**OFFICIAL TRANSCRIPT OF PROCEEDINGS
NUCLEAR REGULATORY COMMISSION
ADVISORY COMMITTEE ON REACTOR SAFEGUARDS**

**Title: MEETING: RELIABILITY AND
PROBABILISTIC RISK ASSESSMENT**

DATE: Tuesday, July 11, 2000

Figure 3-1. Quantitative Objectives for Risk-Informing Regulatory Requirements

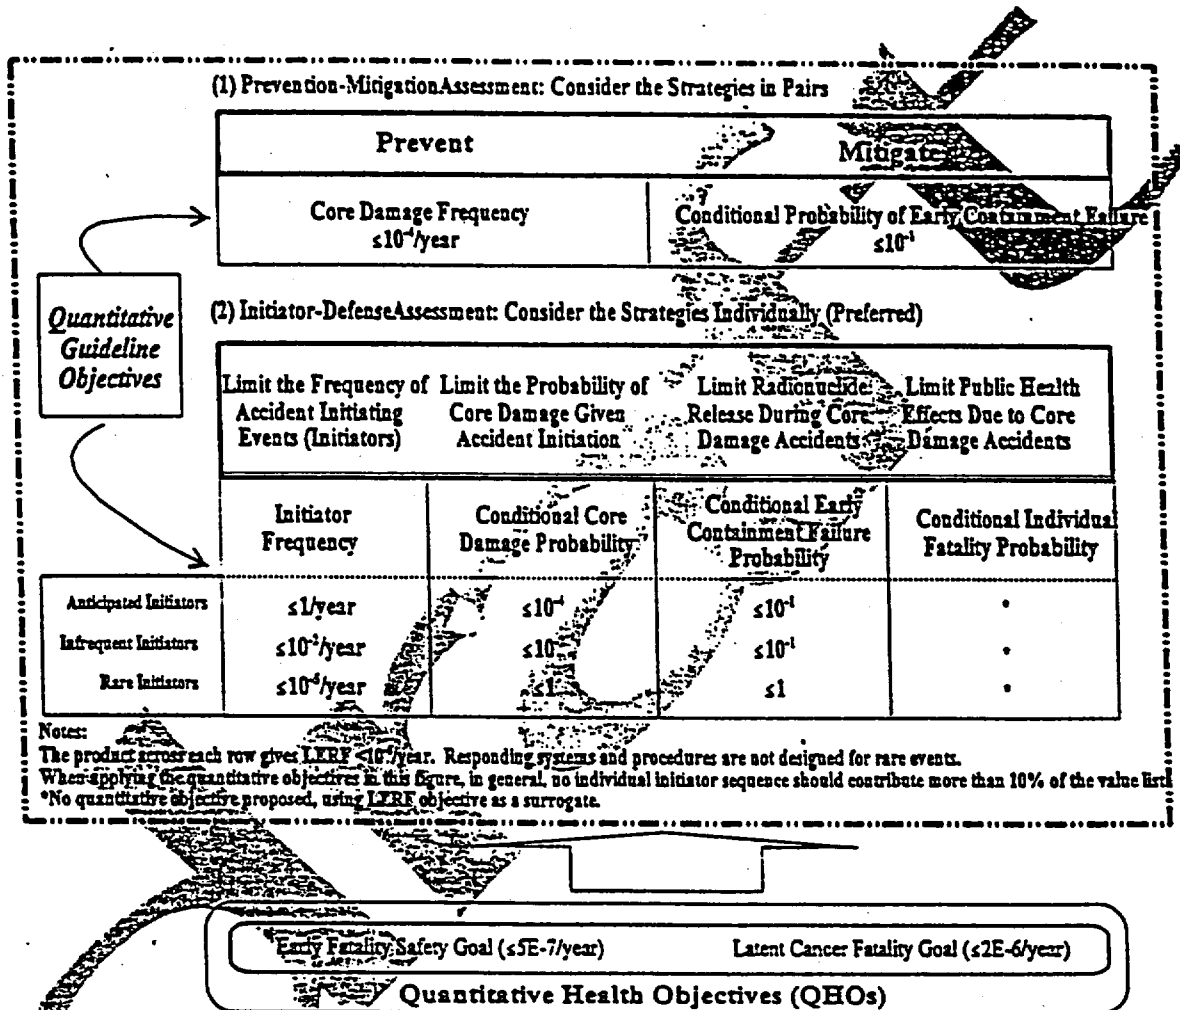
23 DR. APOSTOLAKIS: Okay. So, one question that was
24 raised earlier is under mitigate, condition of probability
25 of early containment failure, right? Why don't we have

3 MR. POWERS: Another question Dr. Kress frequently
4 raises and might be raised in connection with these figures,
5 is suppose that I have done an analysis and persuaded myself
6 that my plant has a core damage frequency of less than ten
7 to the minus four per year. I think Dr. Kress might well
8 ask gee, at what confidence level do you think that you have
9 met that criteria on ten to the minus four per year? I
10 wonder if you have a confidence level in mind for these
11 things?

7 DR. APOSTOLAKIS: Okay, we're back in session.
8 Anything else that the Subcommittee members have on this
9 figure 3-1, which would you please put back up? It's very
10 important.

11 You know, a big question in my mind is how does
12 one use a figure like this to actually write individual
13 regulations, but I guess we're going to see examples at some
14 point.

14 MR. BONACA: I have just one more question on the
15 figure which we raised during the Subcommittee meeting when
16 Mr. Christie made a presentation. He had some concepts, you
17 know, similar. The issue is here you're looking at, for
18 example, containment failure probability, and there you're
19 really introducing a criteria that is used typically in
20 probabilistic risk assessment. I mean, you're looking at the
21 ultimate capability of containment, which is not really what
22 the units are committed to in core design. It would be to a
23 different kind of volume.

22 DR. APOSTOLAKIS: If you replace a conditional
23 early containment failure probability by conditional early
24 radioactivity release probability, then I don't need to go
25 there.

16 DR. APOSTOLAKIS: Now, another point I want to
17 raise here is the issue of external events. I remember that
18 somewhere in the document we're saying that some initiators
19 cannot really be handled in a neat way like, you know,
20 frequency, condition or core damage and so on. Then you
21 move up, right? Like an earthquake is shaking the whole
22 plant, and it's not really very meaningful to talk about the
23 condition of core damage probability separately from the
24 containment failure probability.

20 DR. APOSTOLAKIS: Anything else on this figure?

21 MR. BONACA: Just I would like to add one thing.
22 I raised an issue before containment. Clearly what was
23 making me somewhat uneasy was the fact of not linking it to
24 the uncertainty section, to the section that later on talks
25 about this, you know, regarding uncertainty. That should

19 MR. KING: And since it was really talking about
20 containment performance, we really only use the numbers in
21 the one column, but we basically took risk information for
22 the cross section of plants that we had. We looked at how
23 well the conditional containment performance was under
24 hydrogen combustion type events. We found some cases where
25 those numbers were met and some cases where they weren't,

1 and then the question is okay, for those that weren't, what
2 would it take to eliminate the problem that's causing the
3 performance issue, and that's where we talked about, for
4 Mark III's and ice condensers during station black-out,
5 maybe the igniters ought to have alternate power supply
6 because that was really the thing that was driving that.
7 So, I mean, that's the way it worked.

13 MS. DROUIN: No, no. The regulation would say
14 that we want them to have a hydrogen control system that is
15 capable of meeting their risk significant accidents. Now,
16 they can come in and either show that station black-out as
17 an accident is not contributing, or if station black-out is
18 contributing, they can deal with it. So, we are not
19 prescribing that they have to have D.C. power back-up, but
20 we have analyses, you know, that show for some ice
21 condensers and for some Mark III's that they're having
22 relatively high conditional containment failure
23 probabilities against our guideline, and we're saying okay,
24 that's a concern.
